### ADDENDUM No. 1

REQUEST FOR QUOTATION No.: 1220-040-2022-040

TITLE: SUN SHADE STRUCTURES

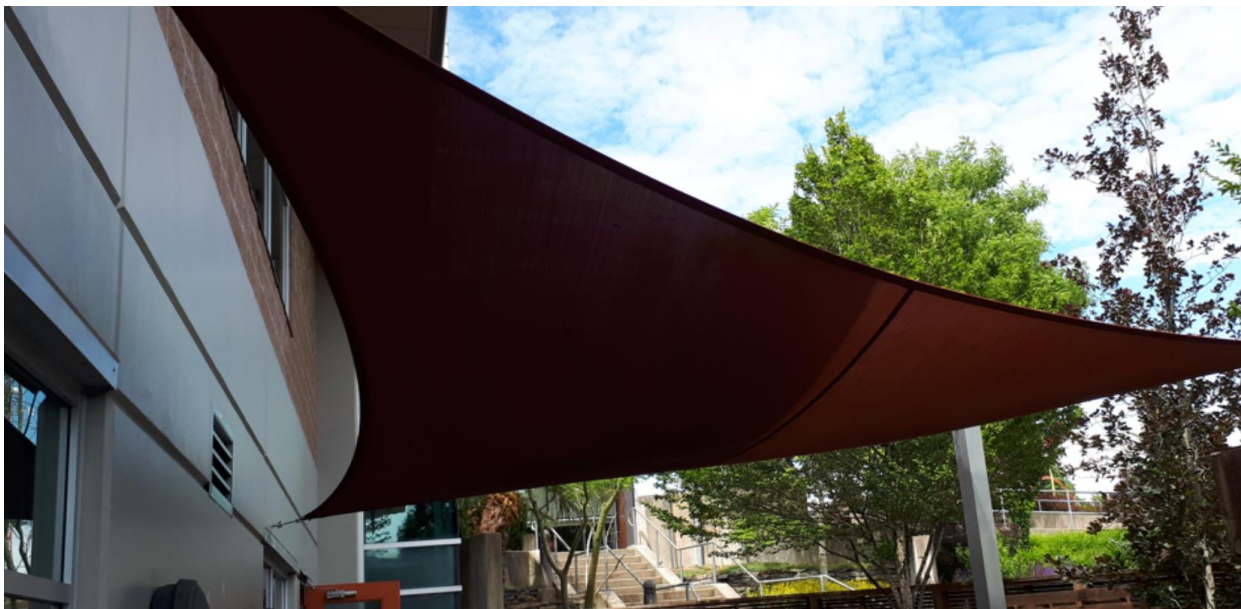
**Q2. What is the size of the unit required for Chuck Bailey Recreation Centre?**

**A2. Not yet determined as Chuck Bailey is under construction. This will be provided later.**
